Inspection of aileron weight and aileron c.g. and inspection of play (backlash) in aileron and flap control circuits to avoid flutter risk.

Glider model ASW 20, s/n 20 001 thru 20077 and 20 086.

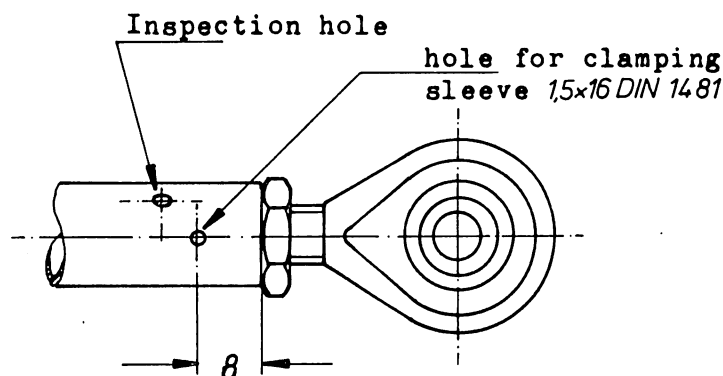
- a/ If new hollow tubular rivets including tools are available, the tubular rivet is drilled off.
 - b/ If procedure a/ is impossible, the fairing of the aileron actuator is split off carefully and the whole metal fittings are unscrewed from the ailerons.

The weight of each aileron is determined (don't forget the fairing which is split off) and compared to the tolerances given in the Manuals. If according to procedure b/ the metal fittings were removed, 0.07 kg must be added to the determined weight.

Determination of tailheavy moment of controls by balancing
on a cutting edge done twice (triangular strip)

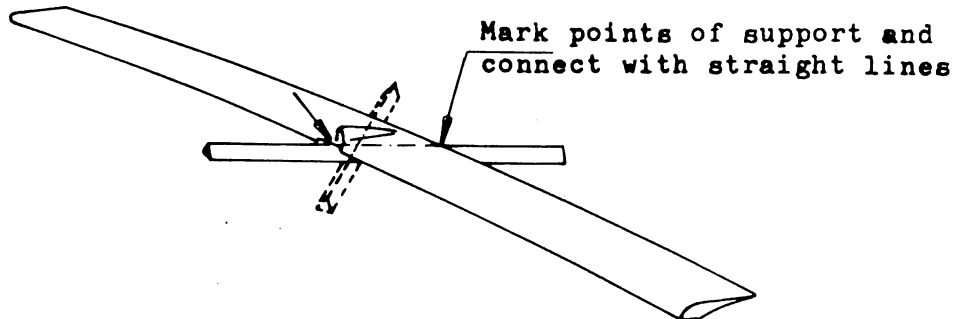
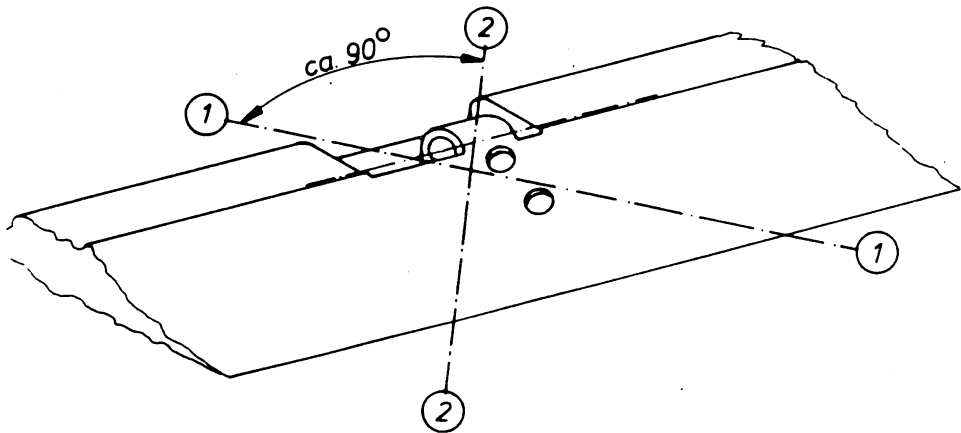
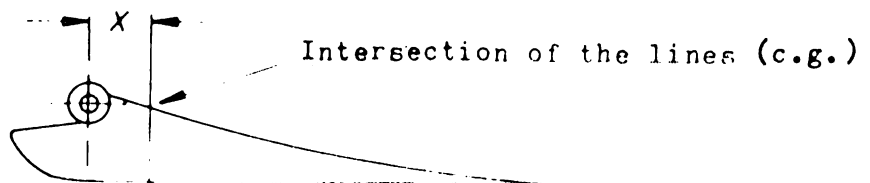
Diverging from the sketch in the Manuals the c.g. of the ailerons is balanced according to the sketch on sheet 5 of this Technical Note. The weight of the aileron (if fittings have been removed, without their 0.07 kg) as determined multiplied by the distance from the c.g. to the hingeline is the tailheavy moment of the aileron. If the actuator fitting was removed, 0.15cmkg must be added. This total moment must not be greater than tolerated by the Manuals.

The connecting lines of the points of support ① - ① and ② - ② intersect in the c.g.

X = Distance from the c.g. to the center of the hingeline.

$$\text{Weight (kg)} \cdot X \text{ (cm)} = \text{Moment (cmkg)}$$
